Thor Motor Coach Technical Service Bulletin

TSB #	TSB 19-02		
Description/Title:	Wi-Fi Power Not Connected		
Affected Product Line(s):	Certain 2020 Model Year Hurricane and Windsport motorhomes		
Service Campaign # :	RC000174	Released Date:	9/20/2019
Repair Codes:	Repair: TMCTS80255W	Document Date:	9/20/2019
Time Allowed:	Repair: 0.5	Document Revision:	A

Figure 2

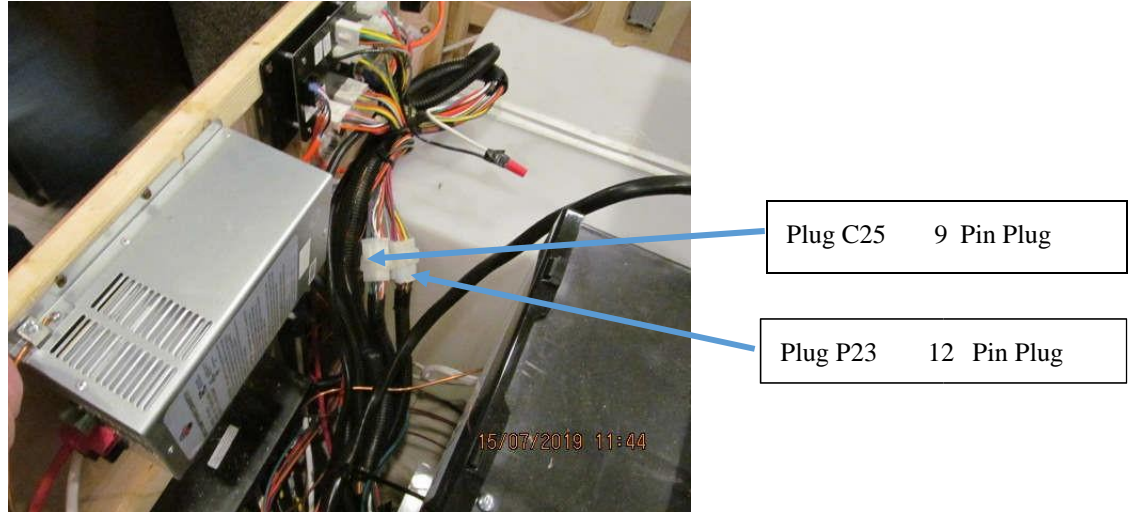
3. Locate the chassis harness plug P23 and C25 they are right behind the load center (Figure 2).

4. Verify that the 18GA orange wire in the plug P23 position 12 is present. If the plug socket 12 is empty, no further action is needed. Proceed to Step 8.
5. If the 18GA orange wire is present, use a pin extractor tool to remove wire from P23 position 12 and insert into C25 position 9.
6. Plug C25 back together to P25.
7. Wi-Fi should now have power. You can test on a browser to verify.
8. Install bed platform and reinstall the removed screws.
9. Reinstall mattress on bed platform.
